City of
Peterborough

Committee of Adjustment Hearing Date: June 16, 2015

Staff Comments re: Files A19/15, A26/15, A29/15, B07/15, A30/15, A31/15, A32/15, B08/15, and A33/15

EXHIBIT **A**
SHEET **1** OF **2**

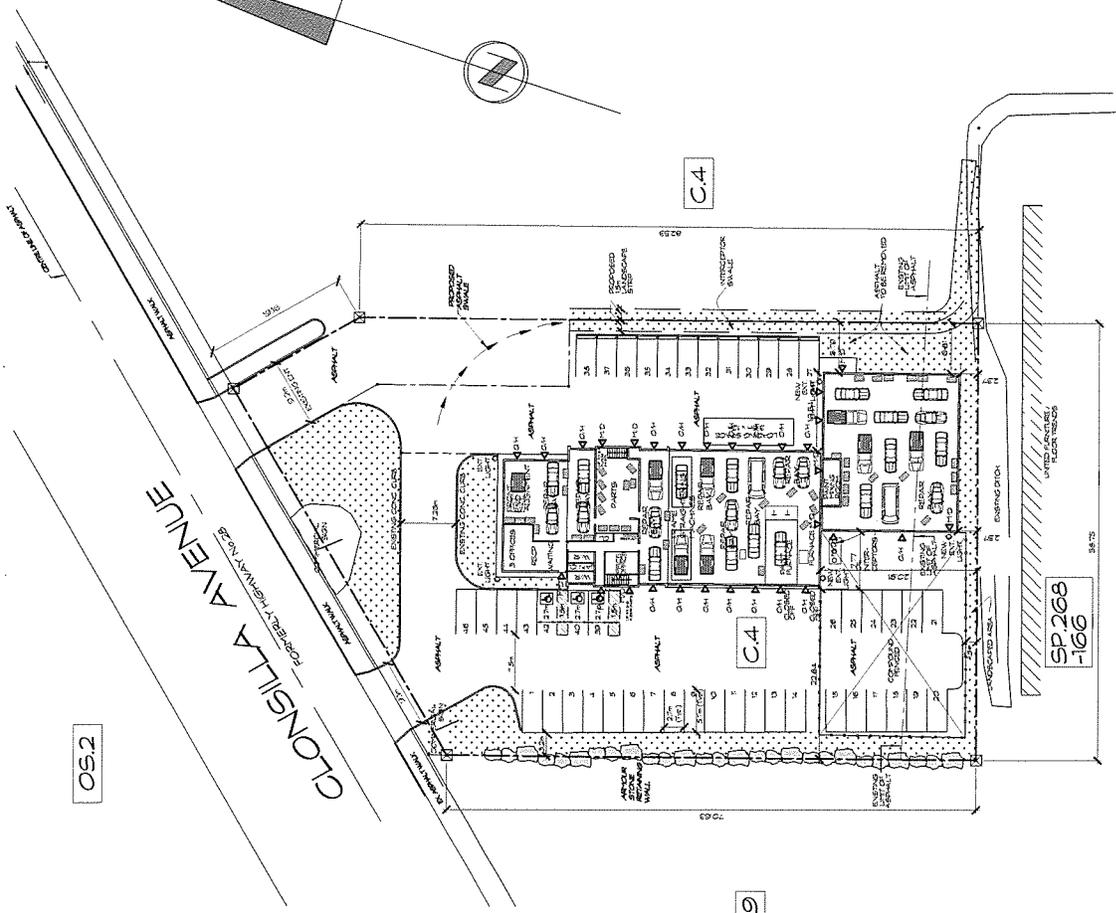
This application was adjourned from the previous hearing on May 20, 2015 to allow the applicant an opportunity to provide further information on the use of the internal space of the building and any modifications to the proposed building addition. Referring to the Plan attached as Exhibit A, the Committee is asked to consider the unchanged proposal for a 389.5 square metre addition to the rear of the building used for automotive repair purposes. The following variances to the C.4 Commercial Zoning District are therefore requested:

The plan attached as Exhibit A provides information regarding the use of the internal space of the building including the proposed addition for auto service bays. Staff considered the nature of the business to be primarily an auto body repair establishment.

Considering the variance requested to reduce the requirement of motor vehicle parking, the Zoning By-law requires motor vehicle parking to be provided at a rate of "the greater of one space per 4 service bays or one space per 9 square metres of service area". On the basis of the latter requirement, a total of 107 motor vehicle parking spaces are determined to be required based on 901.6 sq m of service area and 142 sq m of office area.

The applicant is proposing to provide 46 on site parking spaces based on the addition as proposed. While the number may seem reasonable considering the requirements of other municipalities, the context of the site should be considered in that there is no alternative parking opportunities available off site.

Subject to concerns raised by neighbouring property owners, Staff would not object to the Committee granting a variance to the regulations of the parking requirements to be determined on the basis of no less than “4 spaces per 100 square metres of building floor area used primarily as an auto body repair establishment”.

EXHIBIT E
SHEET 1 OF 1

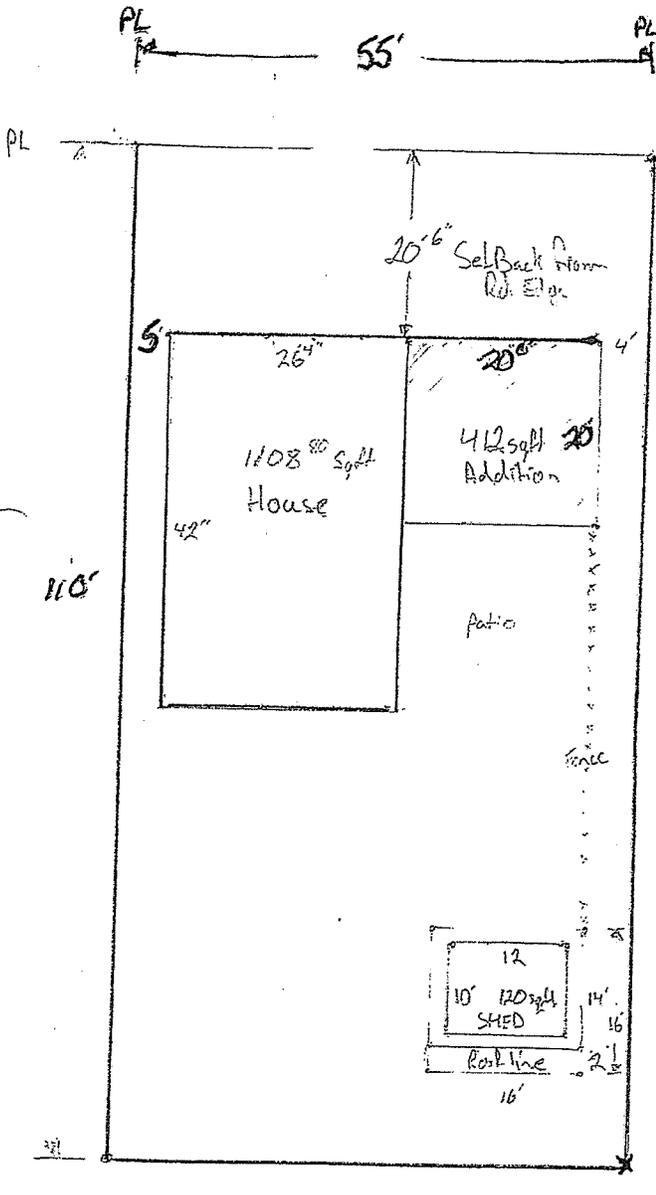
allowance from 24.4 metres to 17.2 metres to permit a proposed two storey addition to the west side of the dwelling on the property that would include a garage that would be in line with the setback of the existing dwelling from the street as illustrated on Exhibit E

Staff visited the site and noted that the dwellings on both sides of the subject property are built across the front of the lot at the same setback. Staff also noted that the proposed setback would leave 6.4 metres (21 ft) between the front of the proposed garage and the street line not compromising the ability to accommodate parking in front of the building addition. Considering the established standard of development in the neighbourhood, Staff would not object to the Committee granting the variance as described provided that the owner establish a 6 metre wide curb cut to the property to accommodate parking spaces for two motor vehicles on the property in front of the proposed building addition.
